AT A REGULAR MEETING OF THE DEVELOPMENT REVIEW COMMITTEE OF THE COUNTY OF JAMES CITY, VIRGINIA, HELD IN THE BUILDING C BOARD ROOM AT 6:45 P.M. ON THE 1ST DAY OF OCTOBER, TWO THOUSAND ONE

Staff Report for the October 31, 2001, Development Review Committee Meeting

The above referenced site plan has been reviewed and the following comments are offered:

Sheet C11

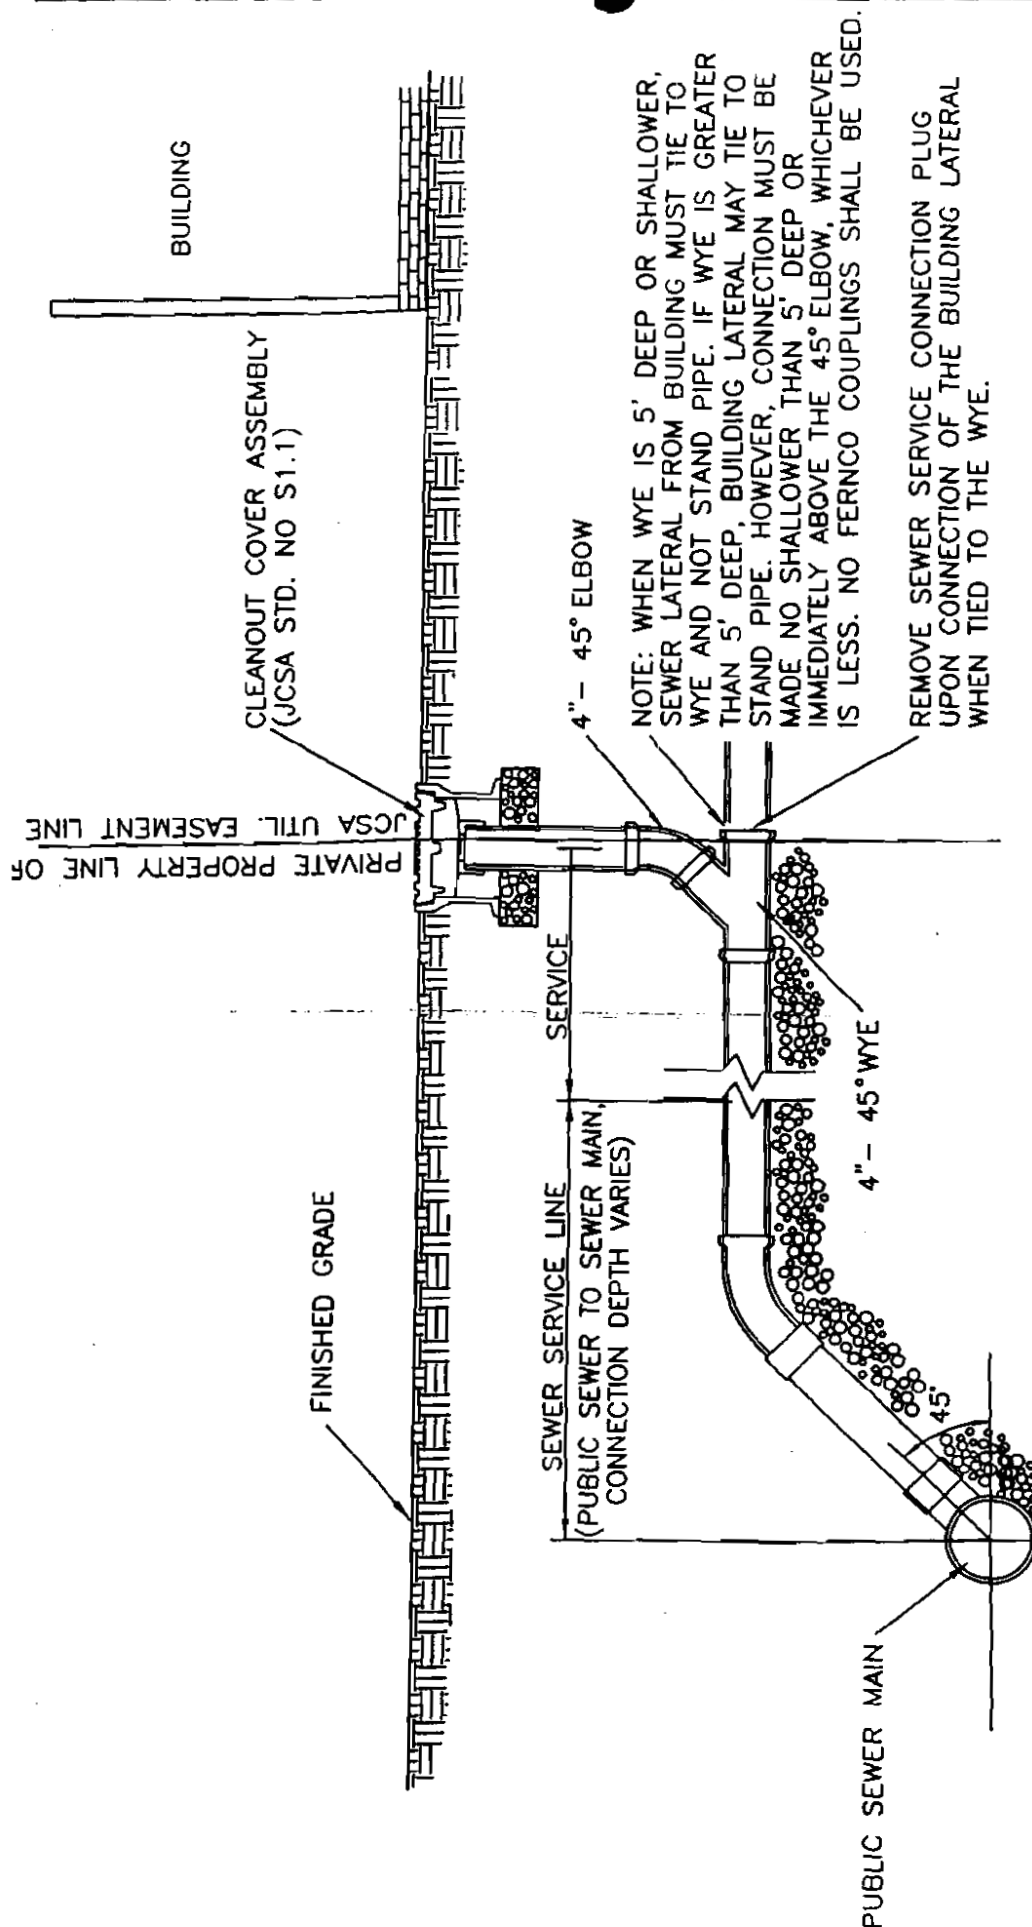
1. Replace the Typical Sewer Service Connection with the revised JCSA Detail, Drawing No. S-1. See attached.
2. The JCSA detail for a drop connection, Drawing No. S5.3, should be added to be consistent with the plans.
